Access Compliance Report Public Rights-of-Way (Curb Ramps)

Main Street: DRUID_LN		Cross Street: FOSTER_RD		Location:	W
ADA ID: RPRK211207113156	Ramp Type: Type 4 - Parallel	Initial Pass/Fail: Fail	Overall Compliance: No	Severity Score:	15
Codes/Mitigation Info/Possible Solution			Field Measurements/Component Compliance

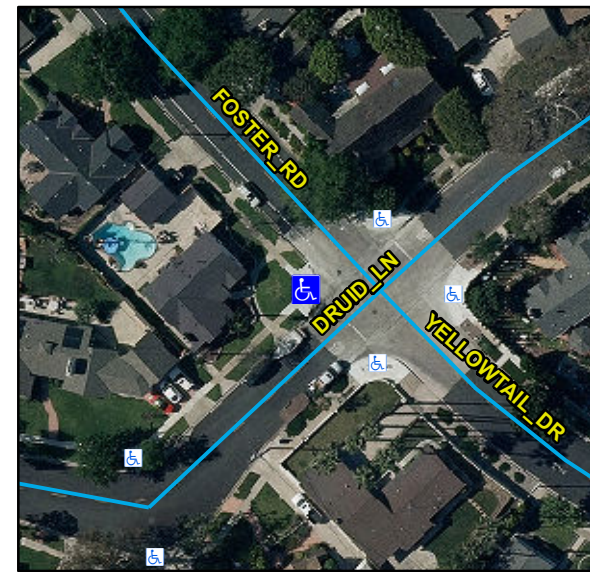
R304.5.3, STD 1115

Remove & Replace Curb Ramp With Two New Directional Ramps or Equivalent.
